Summary of the structural issue:

Response

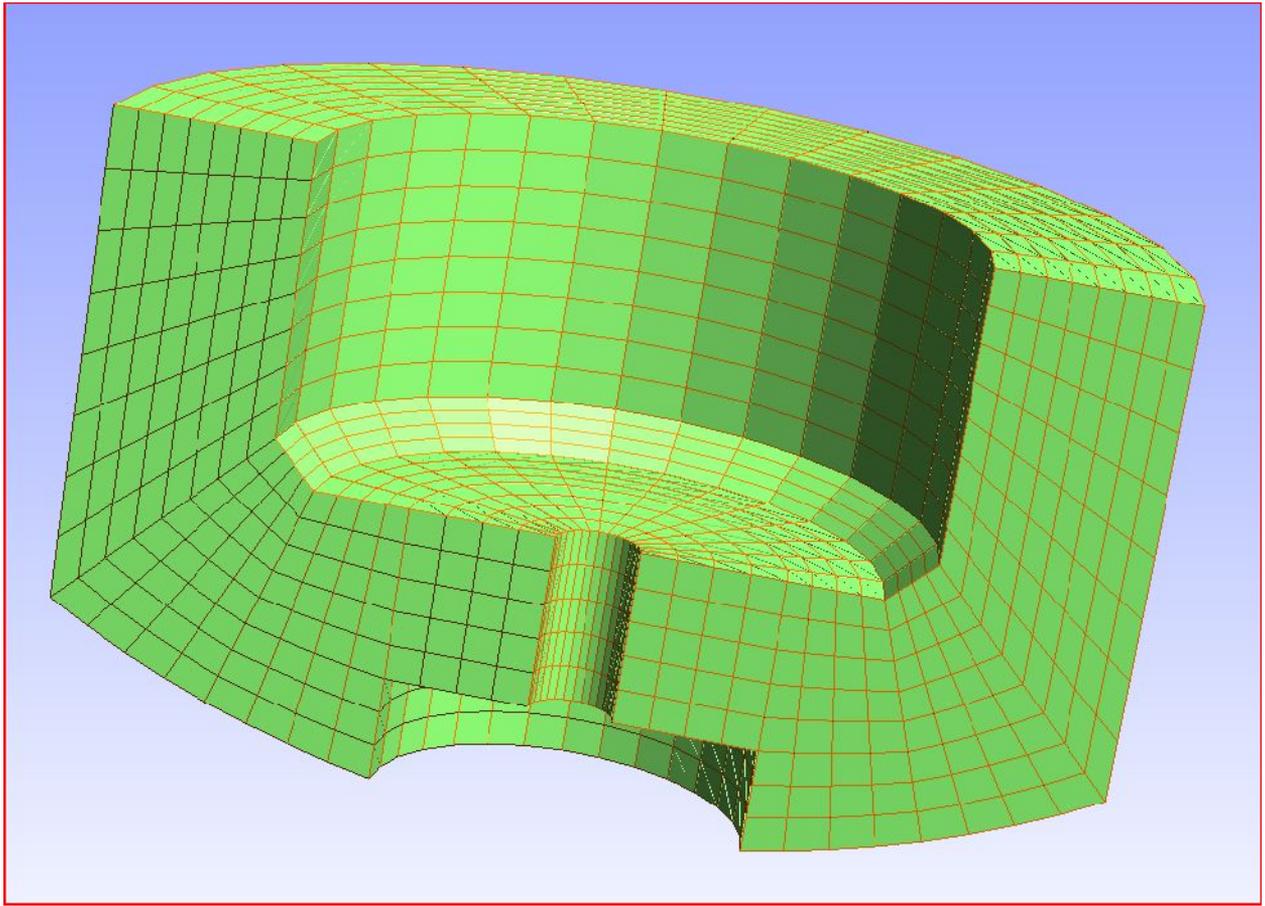
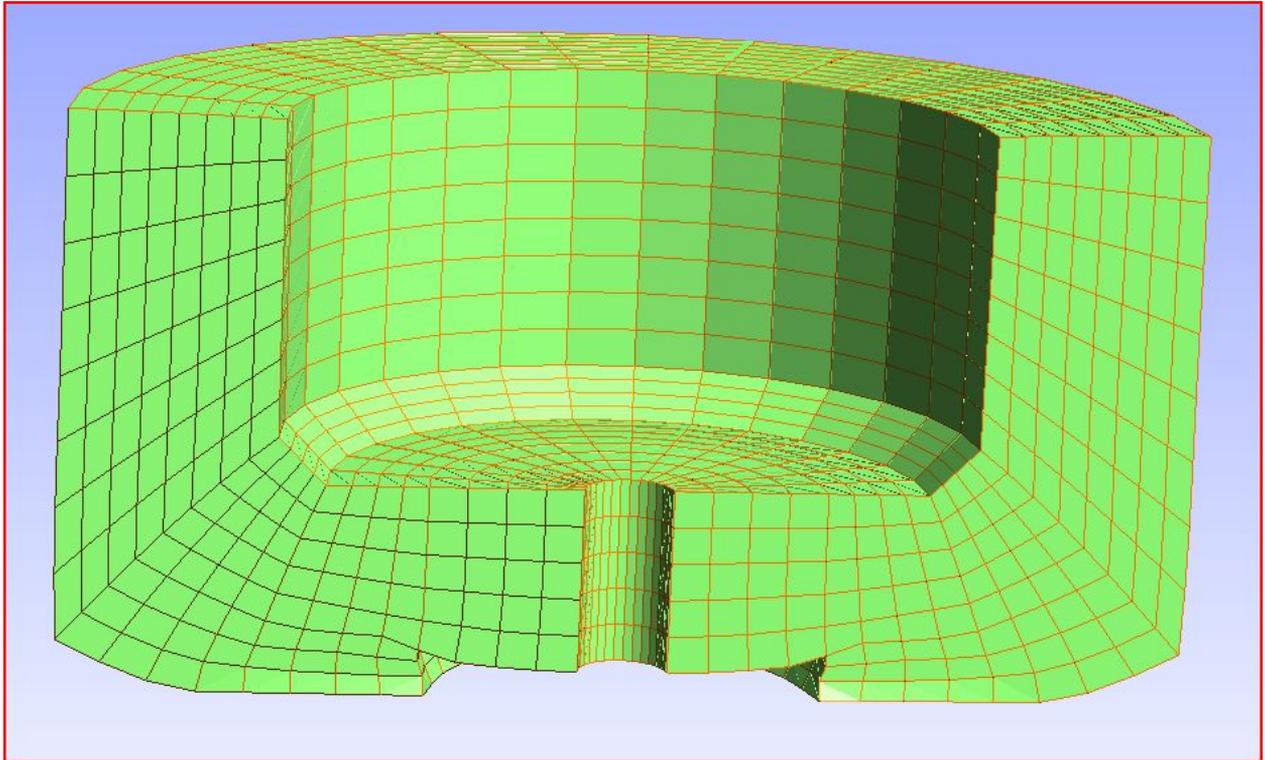
It is apparent from the photograph in Figure 2-32 that the test impact limiter did not deform as assumed in the analysis. Instead of the "bottom" of the impact limiter flattening out (as shown in Figure 2-29), it is obvious that a significant deformation occurred at the "top" of the impact limiter, corresponding to the cask pushing into the impact limiter. This accounts for the deformation at the center of the impact limiter where the foam separated from itself.

Hence, more than half of the deformation in the impact limiter occurs at the "top" surface, and thus the analysis assumption that the "top" is restrained and the "bottom" moves is incorrect. The displacement distribution, and thus the strain, stress, and derived forces, must be incorrect. Similar behavior accounts for the inner surface gaps shown between pre- and post-test profiles in the Side Drop and Slapdown images in SAR pages 2-831 and 2-832.

The method used to analyze the Impact Limiter for drop loads does not simply apply a fixed deformation pattern, but rather uses a capture procedure whereby the structure connects to the rigid impacting plane as the deformation develops. When the constraint forces between the structure and impacting plane become tensile, the constraints are released. In this manner the contact interface develops according to the deformation resulting from the drop, rather than being arbitrarily assigned.

The un-deformed and deformed 165 analytical models for a head-on drop are shown in Figures 1 and 2. We believe the model and analytical method to be both appropriate and adequate for Impact Limiter analyses as verified by the drop test results. In addition, we believe the analytical results show good agreement with the observed behavior and deformations, and the drop tests thereby provide verification of our analytical methods.
